OIA request

Records of communications between NZTA and WS since January 2019

(A) Communications regarding the 2019 update of the technical bulletin [Driveshaft parking brake failures in commercial and industrial vehicles | WorkSafe](#)

Subject Review of Truck Parking Brake Performance & Requirements

FIGURE 1:
Wheel chock

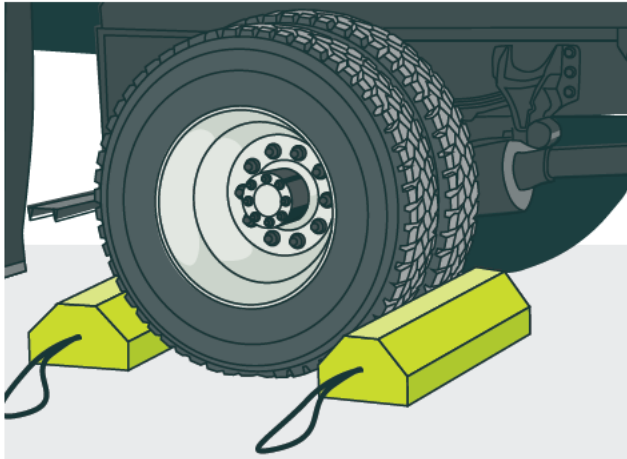
Thanks for sharing that. I have one small comment about a paragraph on training users. I think what we really want to say, first and foremost is that drivers need to be trained to prevent roll aways (deaths, injuries, property damage, etc) and secondary is preventing damage to the brake itself.

Ensure that all drivers of vehicles are trained in and understand the limitations of driveshaft parking brakes and what they need to do to prevent [roll aways], including when wheel chocks must be used; or damage to the brake.
